AMENDMENTS TO THE DRAWINGS

The attached sheets of drawings include changes to FIGS. 1-7, 9 and 10. These sheets replace the original sheets. The annotated sheets show the proposed changes to FIGS. 1, 2, 9 and 10 that accompanied the Letter to the Official Draftsperson filed with the Amendment dated January 13, 2003, proposed changes to FIGS. 3-5 labeling these figures "BACKGROUND ART" to be consistent with the labeling of FIGS. 1 and 2, and proposed changes to FIGS. 6 and 7 to show separate signals being outputted from the first low pass filter 103 to the phase perceiving part 104 and the microcomputer part 105, respectively, and a variation determination unit 105d coupled between the mixing unit 105c and the CRCP 105b.

FIG. 3

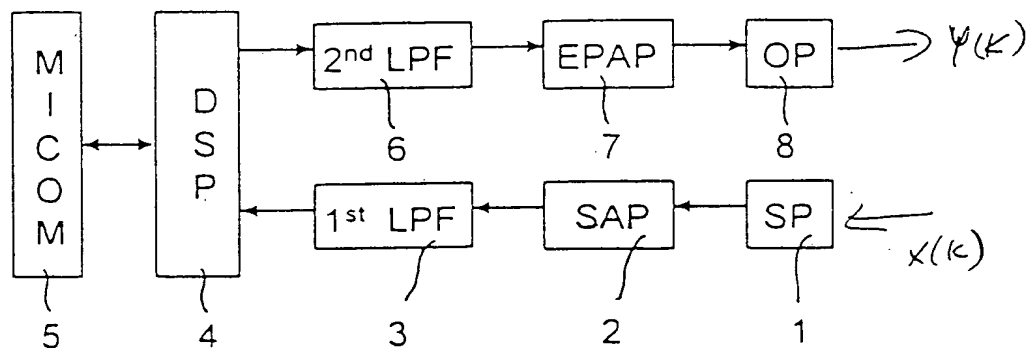
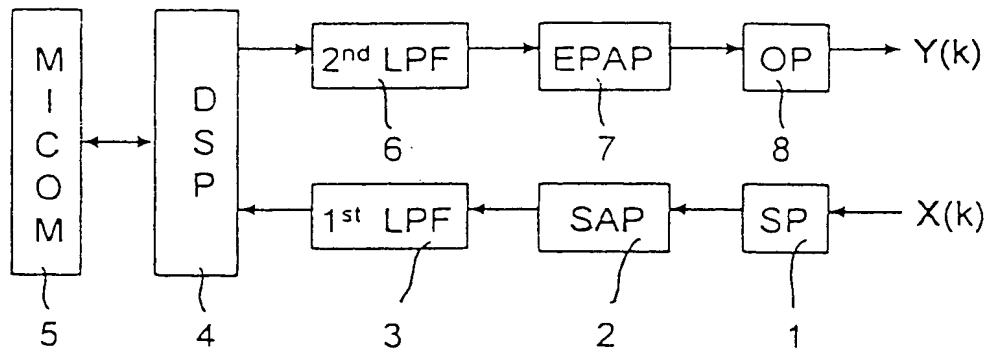
~~PRIOR ART~~ BACKGROUND ART

FIG.3
BACKGROUND ART

FIG. 4

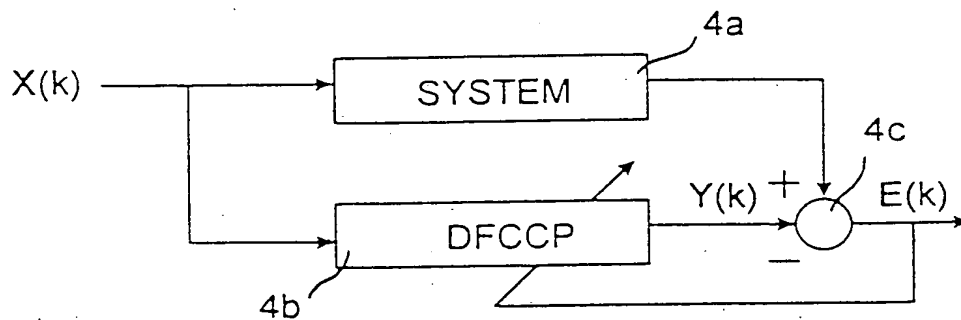
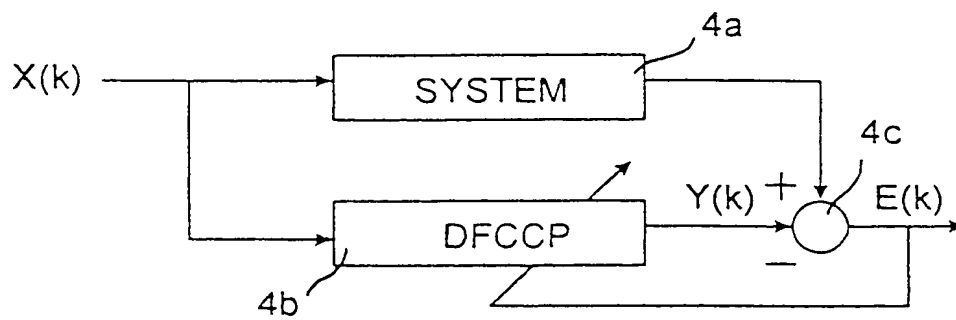
~~PRIOR ART~~ BACKGROUND ART

FIG.4
BACKGROUND ART

FIG. 5

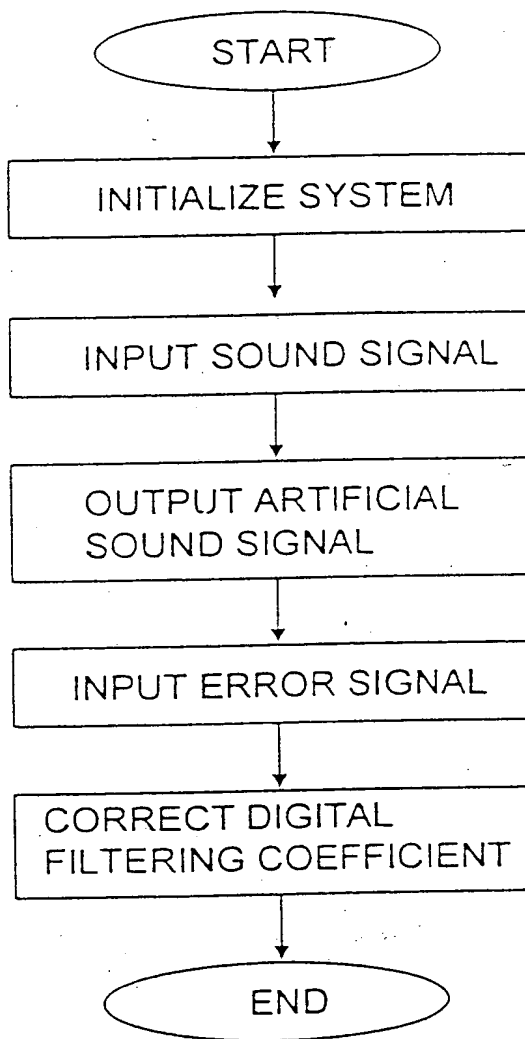
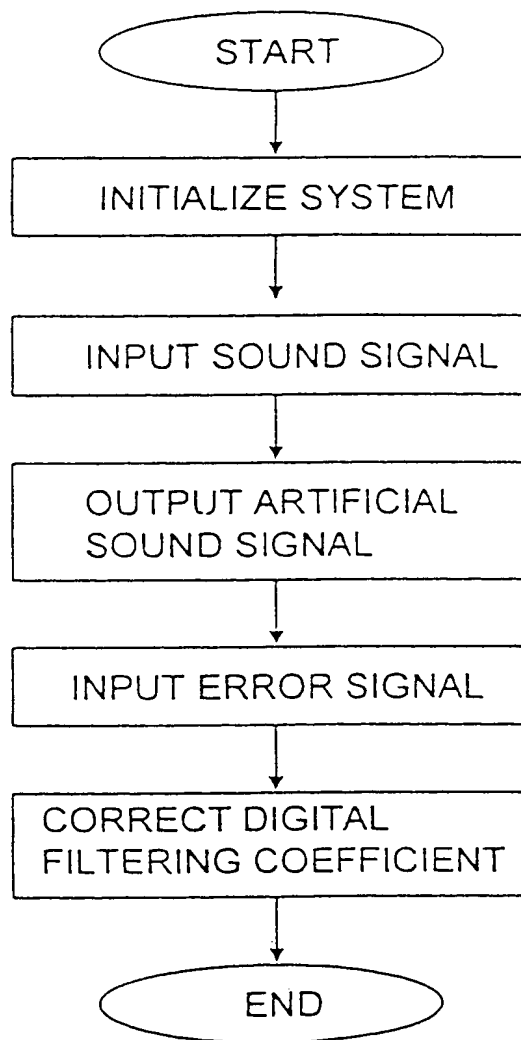
~~PRIOR ART~~

BACK GROUND
ART

FIG.5
BACKGROUND ART
